BECKER, LLC. (Wawa Convenience Store and Fuel Service Station)
Special Exception Use Application
P22-006

SUMMARY

Applicant's Request:	The request is for approval of a Special Exception Use (SEU) for a Wawa convenience store with a fuel service station.
Applicant's Agent:	Brad Curry, Engineering, Design, and Construction, (EDC)
Applicant/Property Owner:	Becker, LLC.
Location:	Located at the southwest corner of SW Port St. Lucie Boulevard and SW Becker Road.
Address:	TBD
Project Planner:	Holly F. Price, AICP, Senior Planner

Figure 3. Conceptual Site Plan

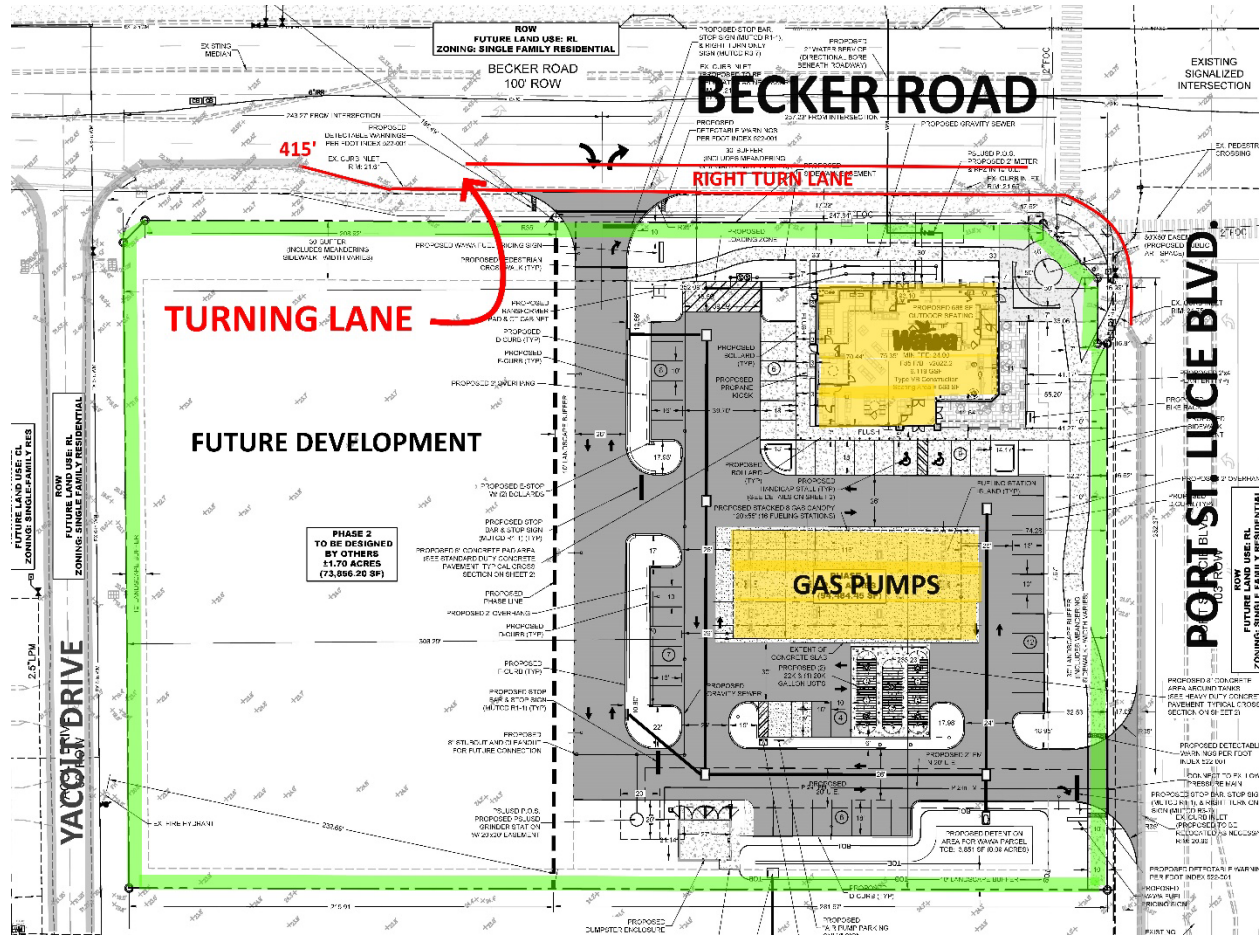
P22-198 Wawa Variance: On August 2, 2022, the Planning and Zoning Board voted unanimously to grant a variance to allow a proposed mid-block driveway to be located in the right-turn lane on Becker Road. See Figure 3. below. Public Works opposed the variance application.

This property is located at a major intersection of two arterial roads on the south side of the city. The property is currently one parcel. The proposed Wawa is located on the east (right) side of the property. See Figure 3. The block length along Becker Road is 498 feet and the distance to the proposed driveway is approximately 257 feet from Becker Road and 243 feet from Yacolt Drive. The driveway does not meet minimum spacing distance. The minimum driveway spacing requirement is 250 feet. More importantly, the proposed driveway is also located in the functional area of the intersection creating a safety concern due to the additional traffic conflict point it creates.

- **Staff findings:** The project as proposed does not meet these criteria. Ingress and egress on Becker Road is not satisfactory. The Public Works Department has indicated that they do not support the proposed mid-block driveway from Becker Road since the driveway would extend from a southbound turn lane – and be located in the functional area of influence near the intersection of Becker Road and Port St. Lucie Boulevard. The southbound turning lane extends approximately 415 feet from Port St. Lucie Boulevard, or almost the entire length of the block. See Figure 3. The proposed driveway would extend from the turning lane. A driveway in this area would cause conflict between drivers wanting to turn right at the corner and drivers wanting to turn right into the property. It should be noted that Public Works does not object to the proposed land use, Public Works just does not support the proposed driveway location due to safety concerns.

- Per City Code Section 158.222(B)(4), the driveway spacing from intersections shall be measured from the right-of-way line of the intersecting street to the midpoint of the driveway. The minimum spacing shall be 250' for a commercial site on Becker Road. However, the applicant is proposing a driveway separation distance of 243'. Of more concern to the Public Works Department, the proposed driveway is being proposed within the existing right turn lane of the Becker Road and Port St. Lucie Blvd. intersection. City Code goes on to state that "standards in excess of these spacing requirements are preferable and may be required for driveways located within the functional area of an intersection or areas where access restrictions are necessary to reduce conflicts, preserve the safety of the traveling public, or to preserve the function of the adjacent roadway."; such as with this particular case to reduce conflicts.

- South Side: The south side has a 10-foot-wide landscape buffer. However, the south of the site side features a gas station canopy, fuel pumps, and parking that would not be screened adequately from view if the hedge is two feet in height as required by code or if palm trees are used, as currently proposed. The fueling station cars, pumps, and canopy would be visible to the neighbors to the south. **Staff recommends that the applicant provide a 6-foot-high opaque fence in the landscape buffer** to provide a visual screen for the neighbors to the south. In addition, the type of proposed trees should include canopy trees such as oak trees, not palm trees, that will facilitate in creating an opaque landscape buffer. If the entire parcel, inclusive of Phase 2 is cleared, the landscape buffer on the south side should be continued along the entire south side of the property. Otherwise, residents to the south will have view of Becker Road.

1) Becker Road Mid-block Driveway Access: Staff finds the requirements of Zoning Code Section 158.224, Driveway Spacing from Intersections, to insure public safety and high-quality public infrastructure have not been met and staff finds that there are viable alternatives that would not create a potentially hazardous driveway configuration at this location. The proposed mid-block access driveway located on Becker Road shall be eliminated. The Conceptual Site Plan shall be updated prior to SEU approval by the City Council.

3) Buffering on South Perimeter Lot: The Conceptual Site Plan and/or Landscape Plan shall be modified prior to SEU approval by the City Council to indicate either a 6-foot-high opaque fence in the landscape buffer. In addition, the type of proposed trees shall include canopy trees such as oak trees, not palm trees, and other vegetation that will facilitate in creating an opaque landscape buffer. If the entire parcel, inclusive of Phase 2 is cleared, the landscape buffer on the south side shall be continued along the entire south side.

Figure 7. Yacolt Street Side Driveway option

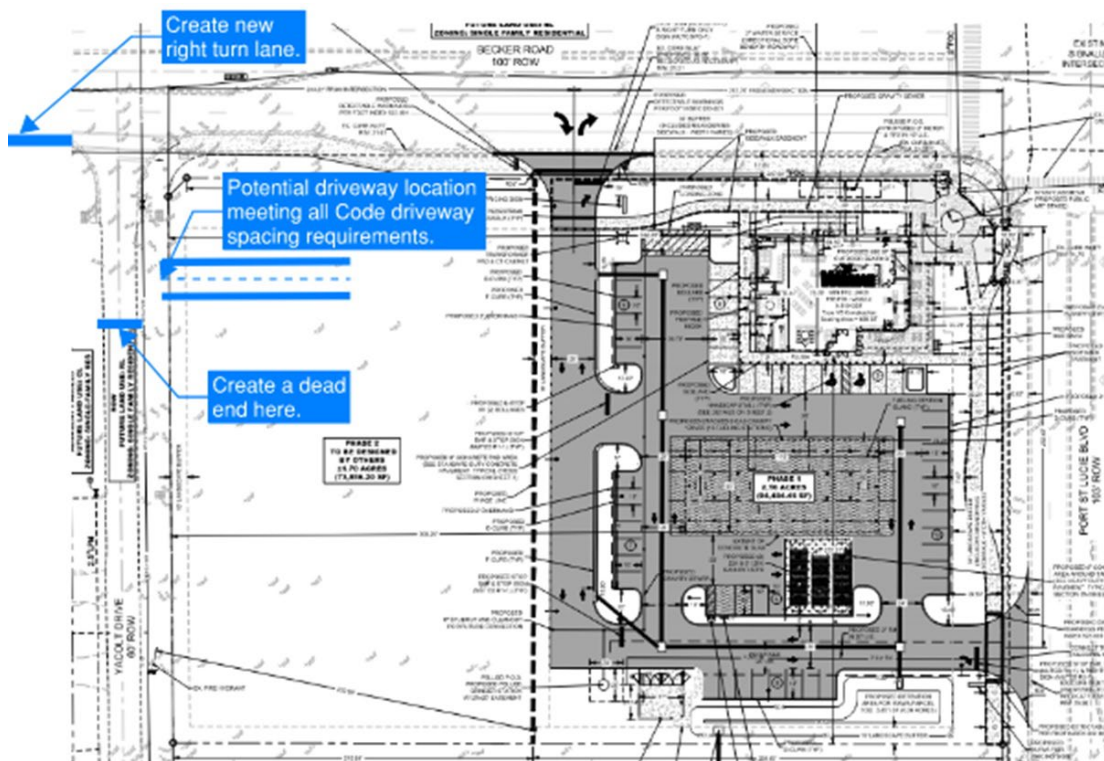
- Staff supports the proposed use with the elimination of the driveway access from Becker due to public safety concerns. Staff doesn't presume to design sites; we review proposals as they are submitted. We do note that this site has other options for site design available. For example, the subject parcel has the potential for a side street access driveway on Yacolt Drive. (The side street access would require a SEU approval process). The city has many properties with side street access where the street leads to a residential neighborhood. This street could be closed off to the south of the side street access driveway to prevent thru-traffic, as was discussed by Public Works and the Applicant multiple times. It is currently possible for traffic heading east on Becker Road to turn right onto Yacolt Drive and then turn left on Abraham Avenue to bypass the stoplight at the corner of PSL Boulevard and Becker Road, and thus allow thru-traffic. See Figure 2. At the P&Z Board meeting, one of the neighbors indicated concern about possible thru-traffic coming from the south via Abraham Avenue. Closing off Yacolt Drive would prohibit drivers coming from Martin County on PSL Boulevard to turn left on Abraham Avenue and then right on Yacolt Drive to access Becker Road or development located on the proposed Wawa site. The map below indicates recommendations from the Public Works Department for driveway access from Yacolt Drive to the subject site.

- It should be noted this thru-traffic will only increase with the Martin County Pinelands Prairie development directly off of Port St. Lucie Blvd. (Citrus Blvd. when in Martin County). This thru-traffic would be mitigated with the dead ending of Yacolt Drive just south of the desired driveway location.
- According to Section 2.3.3.c of the Becker Road Overlay District (BROD) Design Standards, side street access for properties located in the Activity Center Subdistrict requires SEU approval.
- The proposed sidewalks meet the requirements of the Becker Road Overlay District Design Standards and provide adequate pedestrian ingress and egress.
- The applicant provided an auto-turn study that shows that large delivery trucks have adequate turning radii for ingress and egress to the site. See Auto-turn Analysis attached to this report.

2) Yacolt Drive Side Street Access: If side street access to the subject site from Yacolt Drive is provided, a right-turn lane from Becker Road to Yacolt Drive shall be provided and Yacolt Drive shall be closed to thru-traffic. These improvements shall be located in the area to the west of the subject site. Such changes shall be reflected on the Conceptual Site Plan prior to this SEU approval by the City Council, and the side street access requires it's own SEU which should be advanced to the City Council at the same time as this SEU.

Public Works recommends moving the driveway location from Becker Road to SW Yacolt Drive. By providing a right turn lane on Becker Road to SW Yacolt Drive and then blocking off SW Yacolt Drive south of this Wawa Property entrance, the driveway will meet all required Engineering Standards for spacing and safety. By blocking off SW Yacolt Drive, this will also prevent all cut through traffic that could occur from Port St. Lucie Blvd and Abraham Avenue, therefore reducing any unnecessary nuisance to the surrounding neighborhood.
